ISSUE	DATE	AMENDMENT
01	25.06.10	For inclusion in Development Application
02	27.07.10	New elevations for inclusion in Development Application
03	15.10.10	Council request for additional information
04	28.01.11	Council request for additional information

DEVELOPMENT APPLICATION
New Independent Living Units
Lourdes Village
95 Stanhope Road, Killara
For Aevum Limited

DWG NO
DA.00

TITLE	SCALE	DATE	DRAWN	CHECKED
Croquet Level 1 + Roof Plan	1:100 @ A1	25.06.10	CKUK	PT
ISSUE	SCALE	DATE	DRAWN	CHECKED
C	1:100 @ A1	25.06.10	CKUK	PT

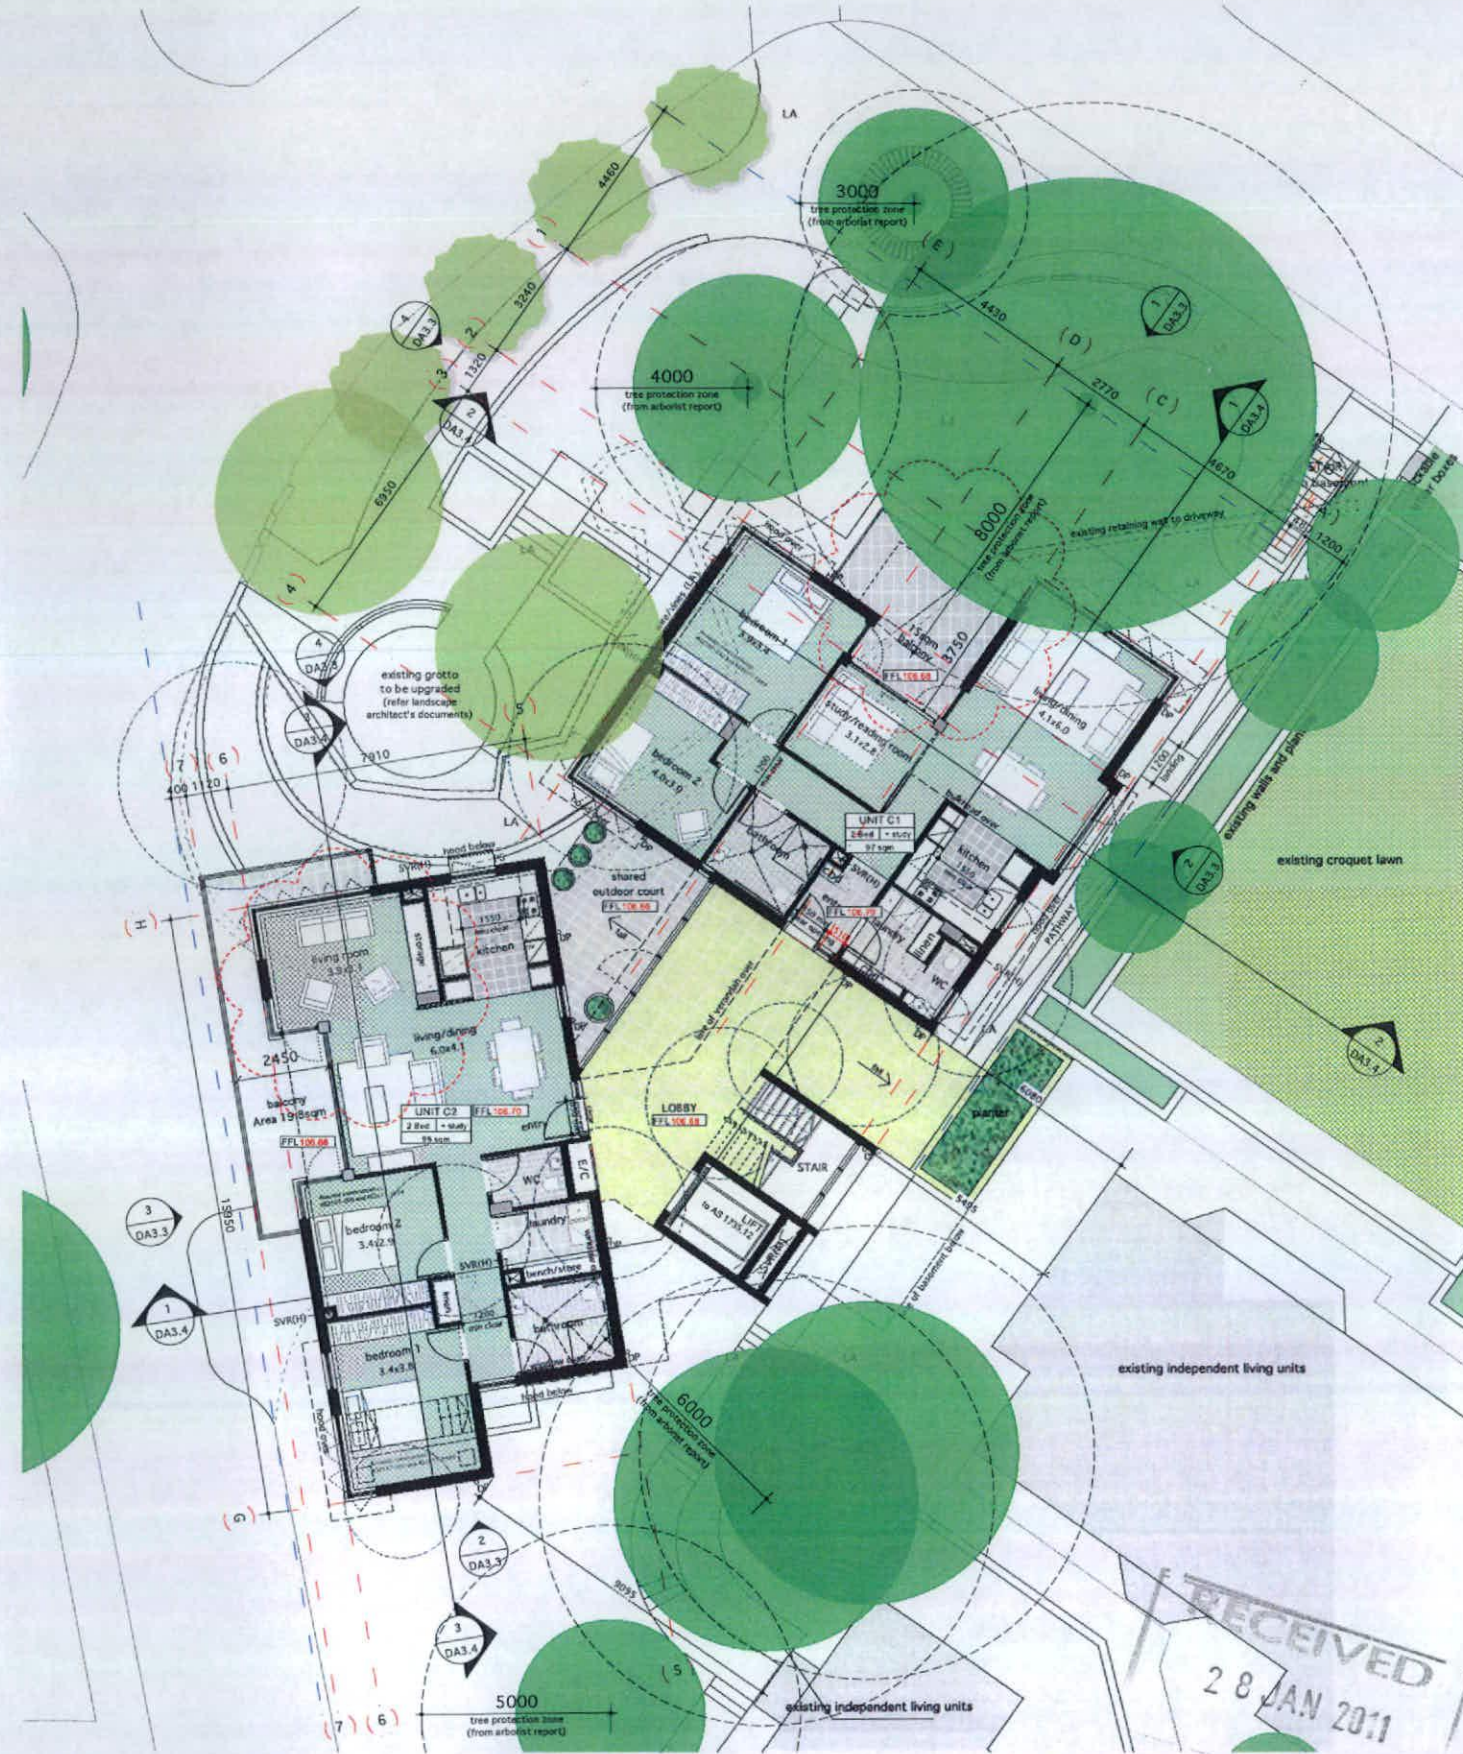
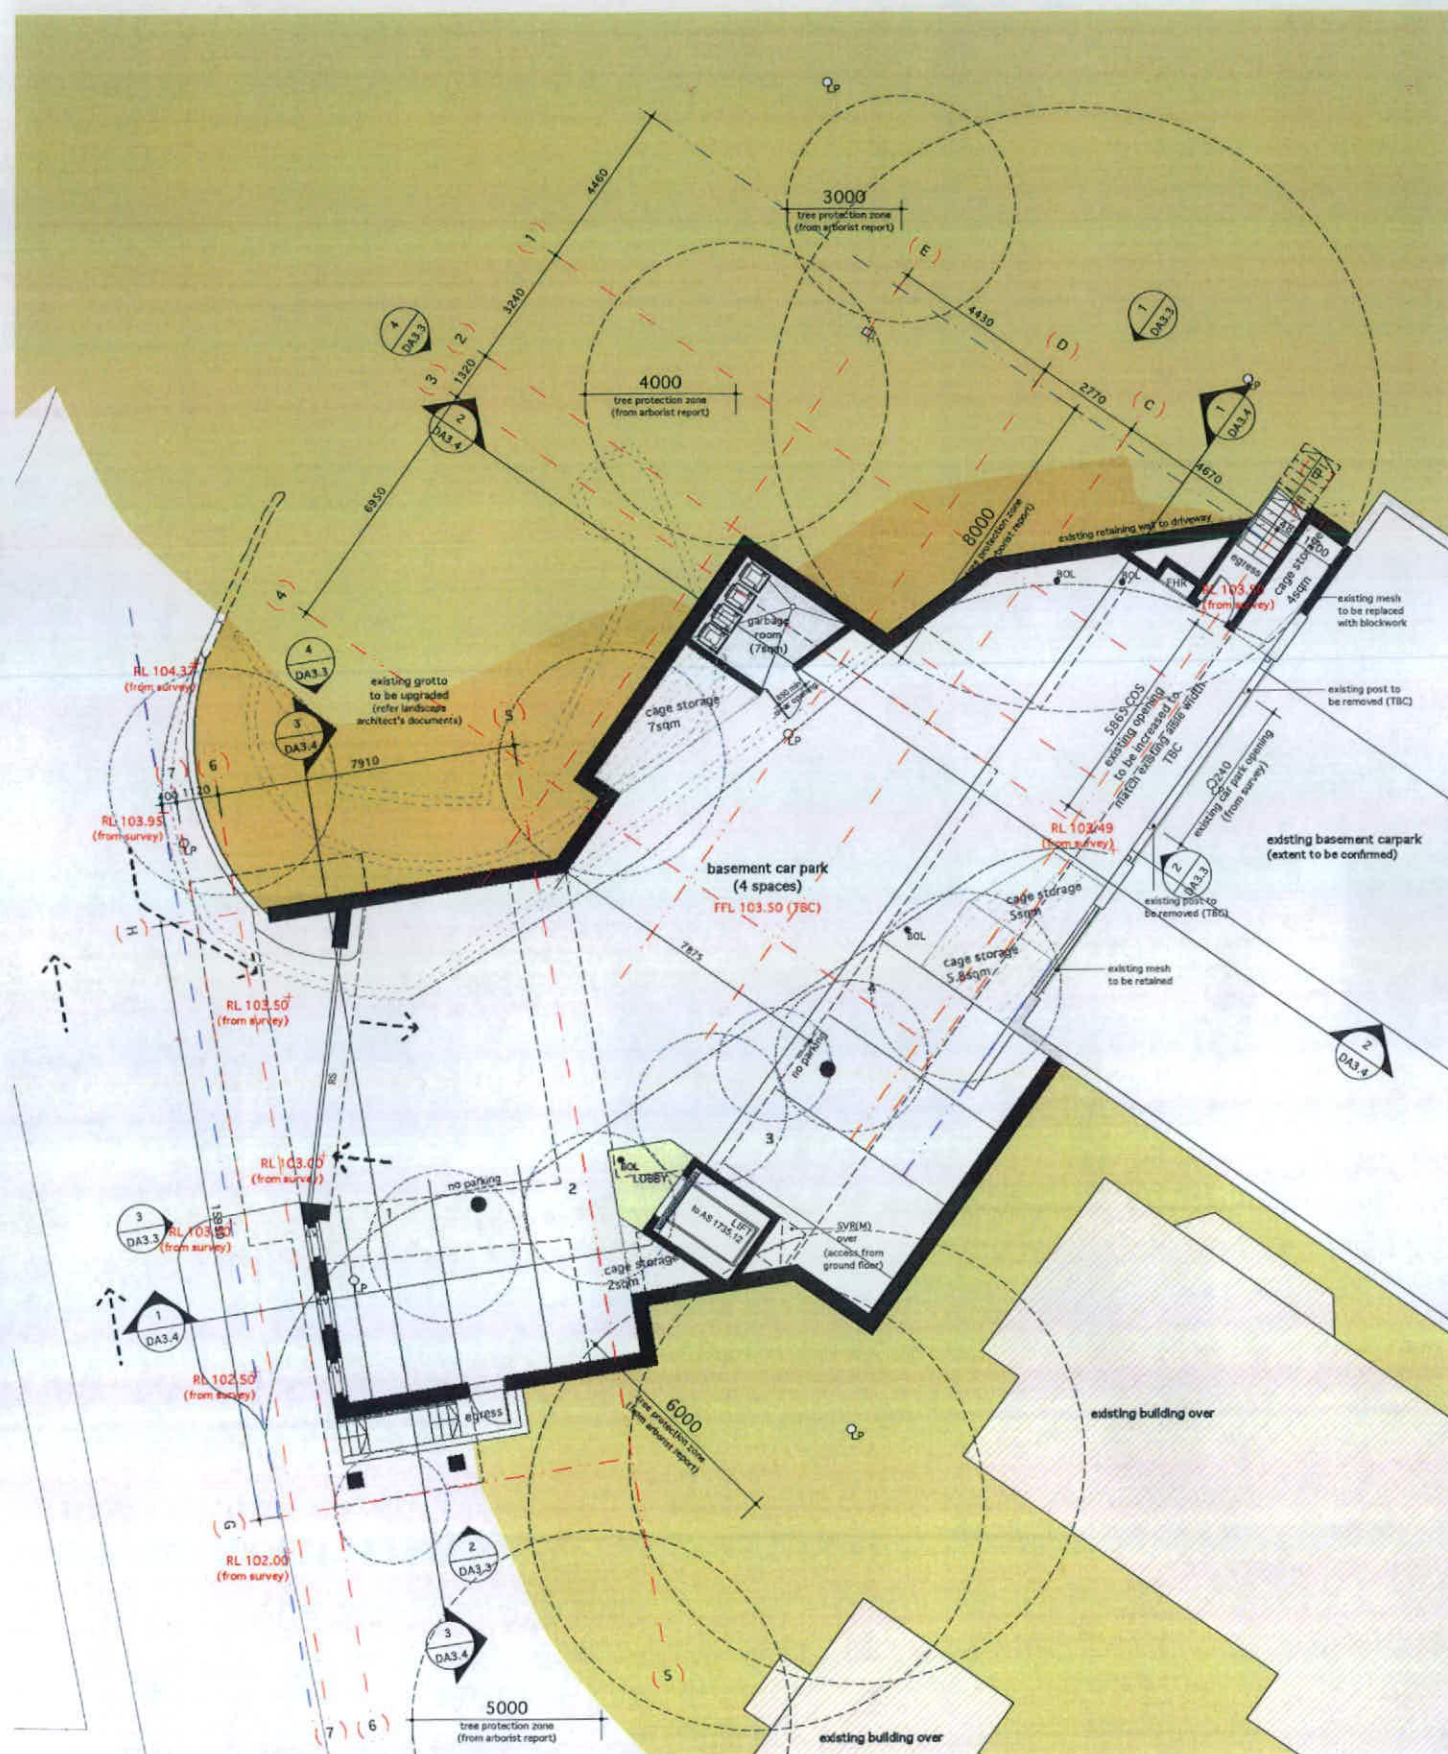
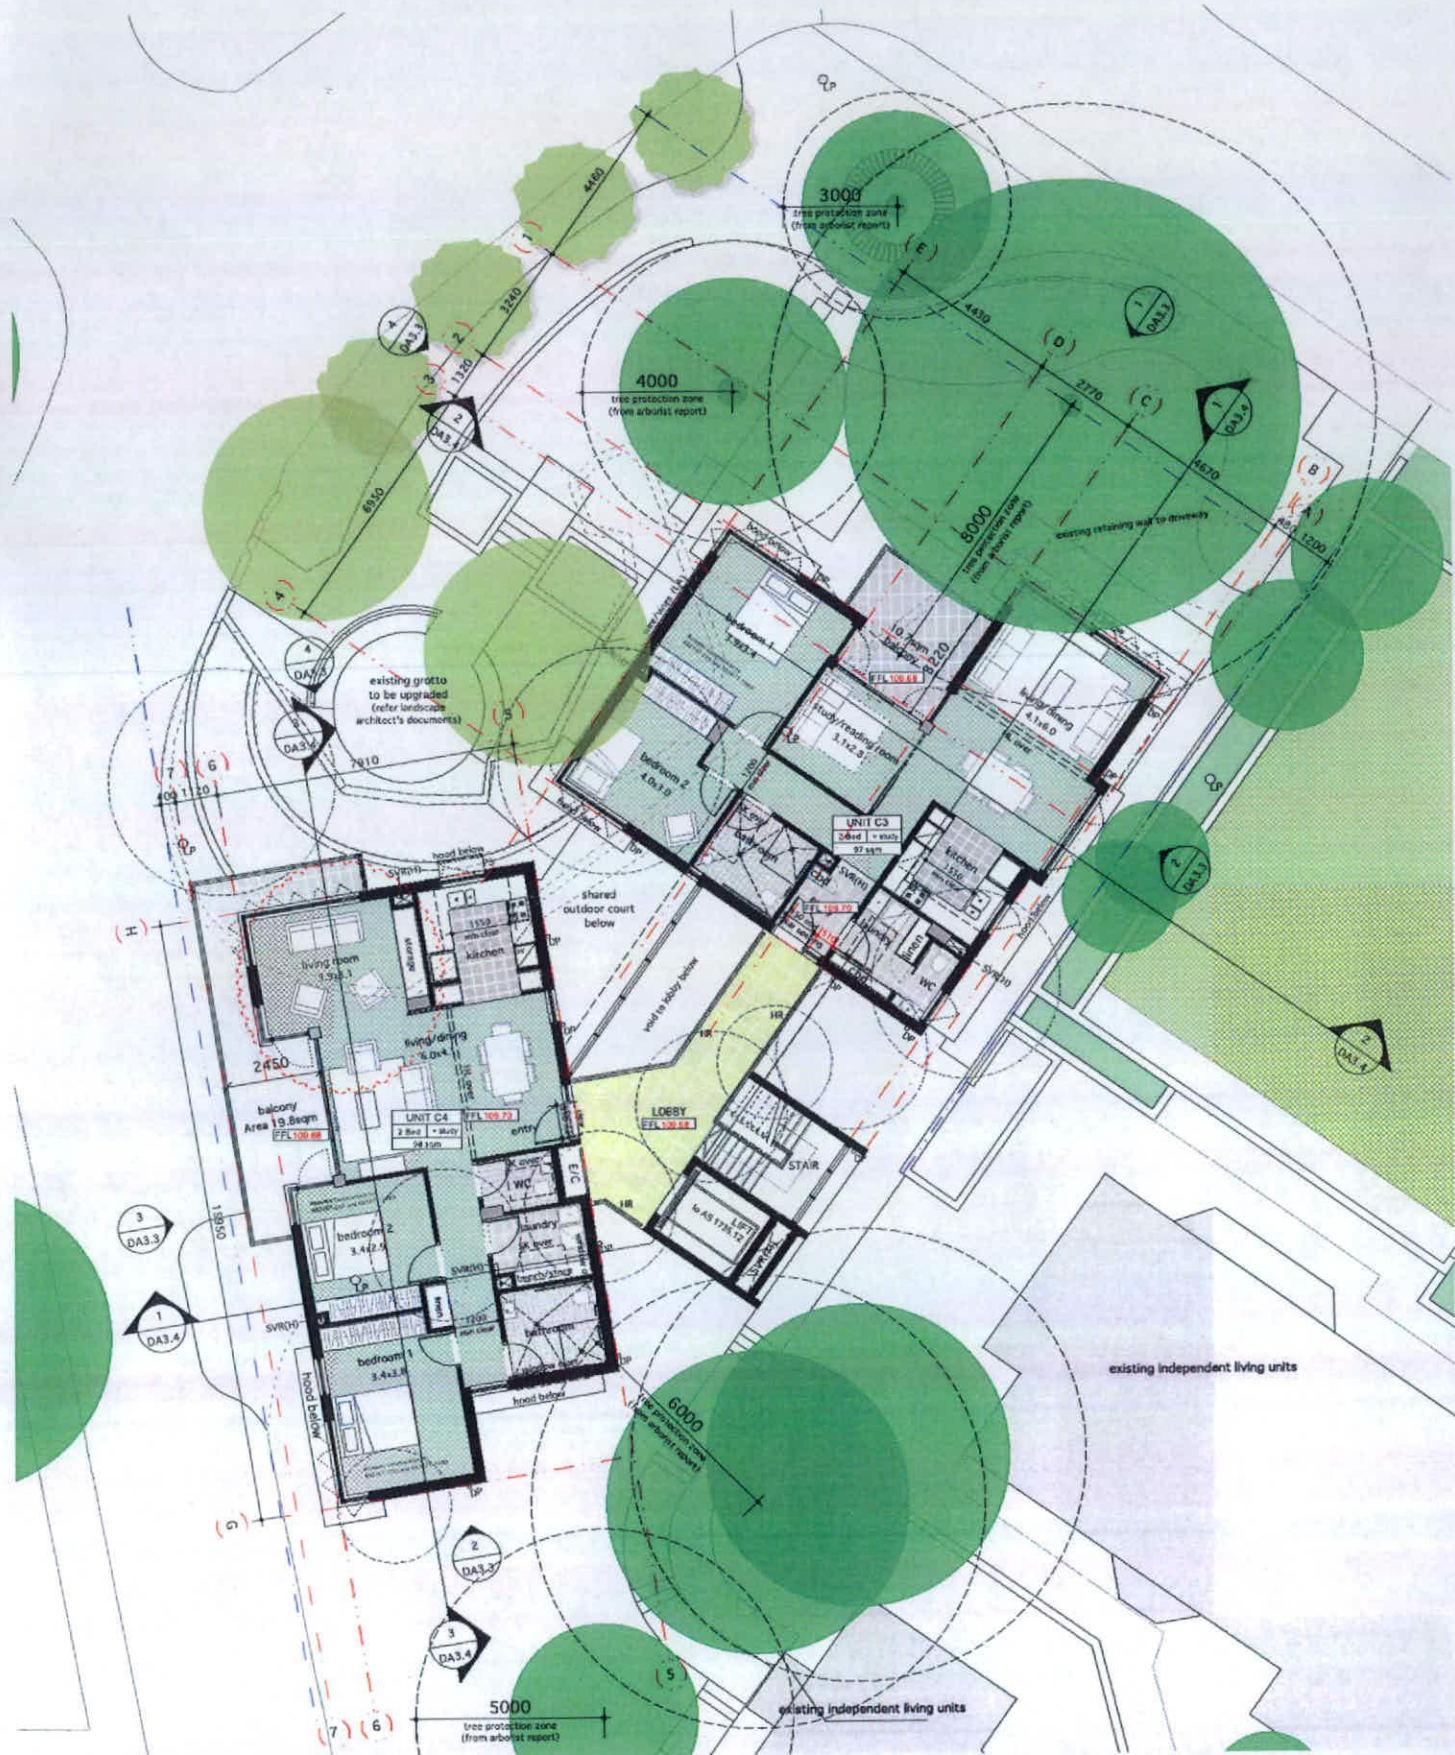
1. Unit C1 enlarged balcony
2. Unit C2 plan revised to open plan living

Amendments Ground level
1. Unit C2 plan revised to open plan living

4 Western Elevation
1:100 @ A1

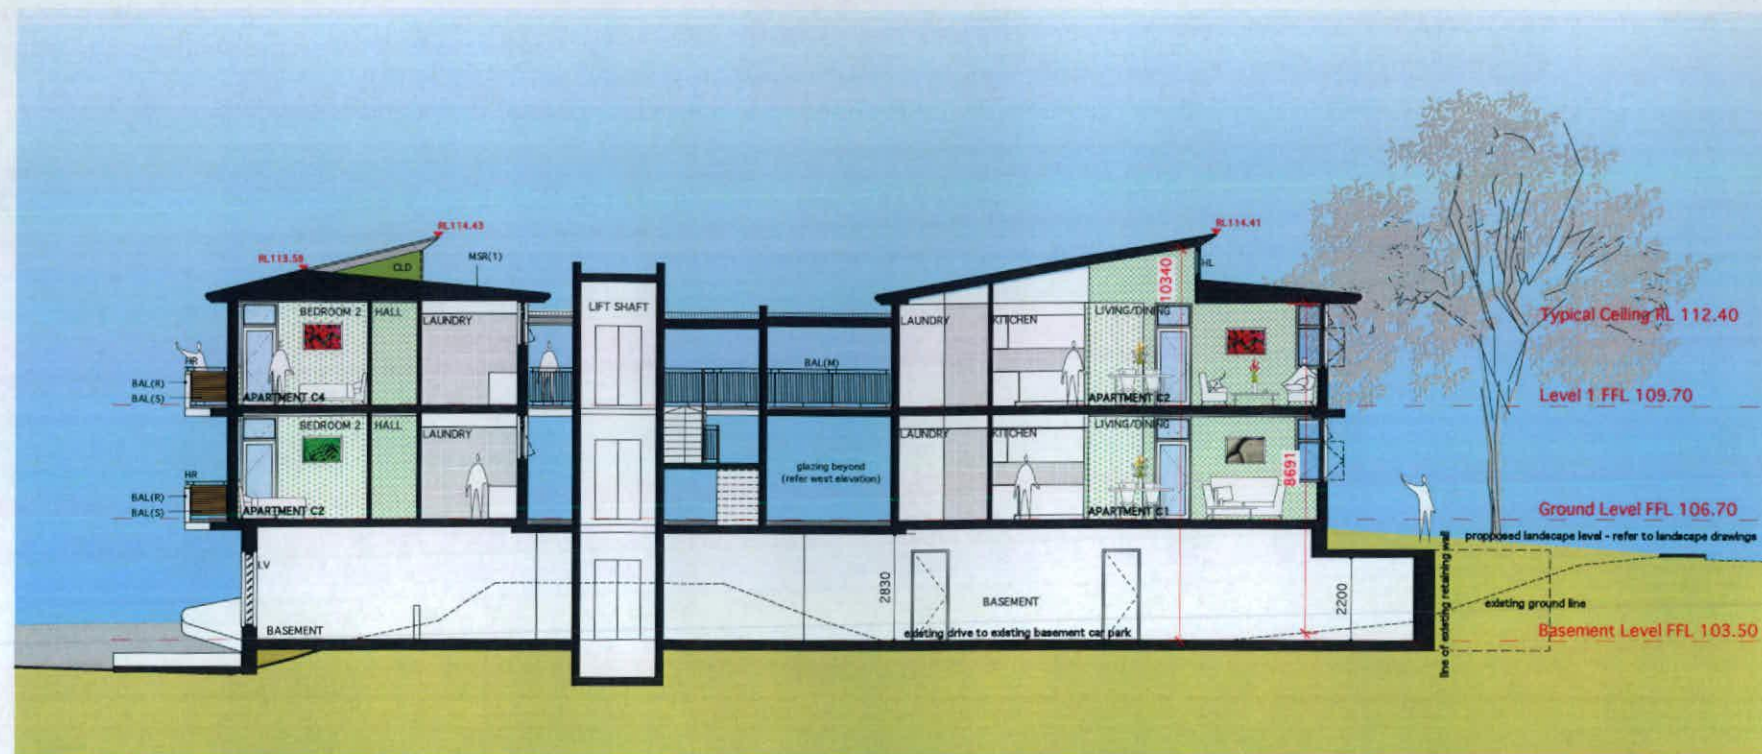
Amendments Western Elevation
1. Increased balcony size on unit C1

1 Courtyard Elevation
1:100 @ A1

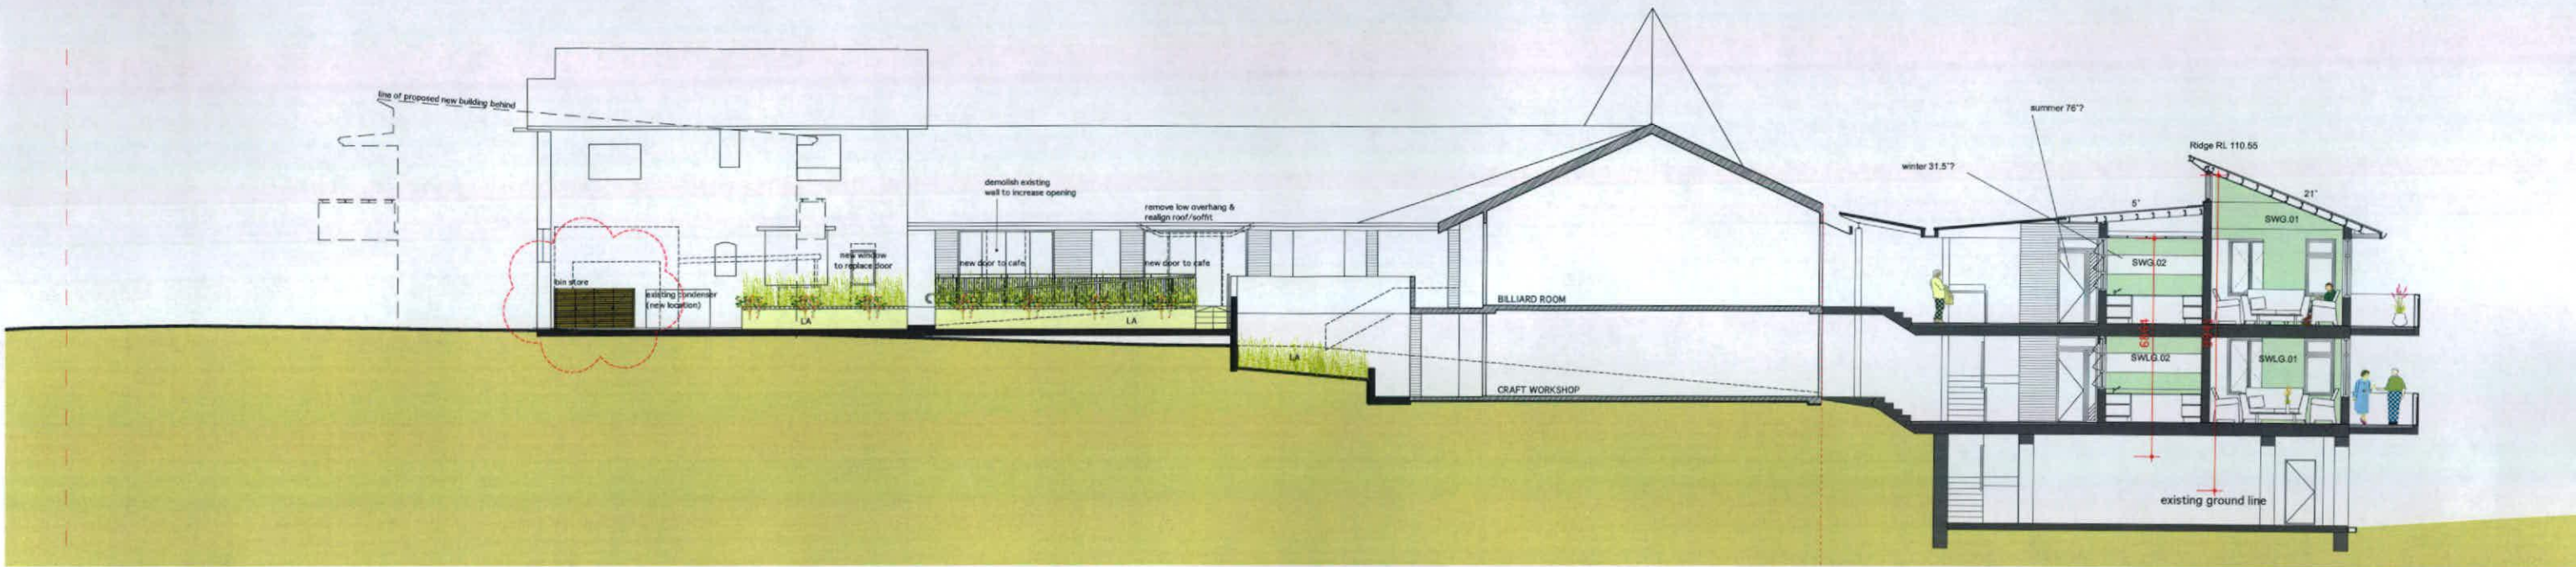
1. Bin store added for cafe/admin waste
2. Proposed new window removed
